SERVICE BULLETIN

M-1209

Safety Recall Code 0132

2006 VRSCR EXHAUST SHIELD RECALL

Figure 1. Inner Exhaust Shield Installation on Rear Exhaust Pipe

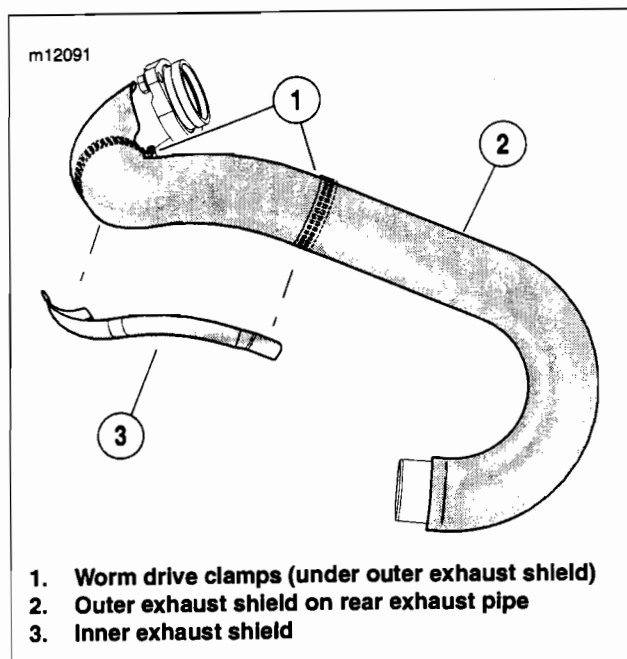
Harley-Davidson has determined that a condition affecting motor vehicle safety exists on 2006 VRSCR model vehicles. These vehicles have a condition whereby the pant leg of some riders can have direct contact with the exhaust pipe. This condition could cause the pant leg to char or burn, which could lead to the possibility of injury to the rider.

In the interest of motor vehicle safety and customer satisfaction, Harley-Davidson has elected to initiate a voluntary recall (0132). Recall 0132 consists of installing an additional exhaust shield on the inner side of the rear exhaust pipe, preventing the risk of the rider pant leg having direct contact with the exhaust pipe. You may sell **but not deliver** any affected motorcycles to your customers until the remedy is completed.

See Figure 1. If the vehicle is equipped with an original rear exhaust pipe (header) which does not have the inner exhaust shield installed, proceed to the installation instructions.

1. See Figure 1. Loosen both worm drive clamps (1) on the upper portion of the rear exhaust pipe.
2. Slide the **new** inner exhaust shield (3) against the exhaust pipe and into the clamps. The clamps should rest on the indented ends of the inner exhaust shield.
3. Tighten both clamps securely.
